**Proposed changes to Ontario Amendments in OESC 2024** (Click on the Proposal Number to view the full description.)

**6.5.2.2 Side marking**

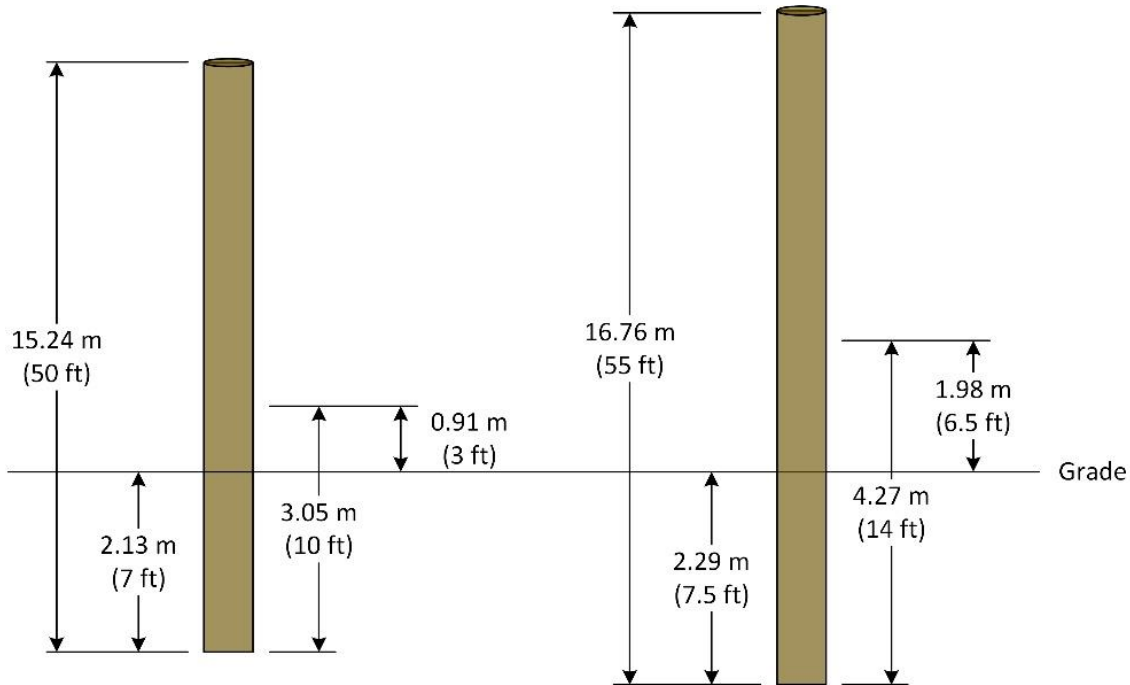
ESA has seen a few installations where some customer owned poles are exceeding the 15.2 m (50 ft) pole length identified in Table 104. Inspectors have questioned the depth of the pole since the side markings are located above the required height above grade as listed in Table 104.

*The bottom of the side mark shall be located on the face of the pole at 10 ft ± 2 in from the butt of poles 50 ft or less in length, and at 14 ft ± 2 in from the butt of poles 55 ft or more in length. In the case of 10 ft, 11 ft, and 13 ft stubs, the mark should be 1 ft from the top.*

Since there are no standards for pole depth, depth of pole rule of thumb = 10% of length + 2 ft. This aligns with Electrical Distributor's approved engineered standards.
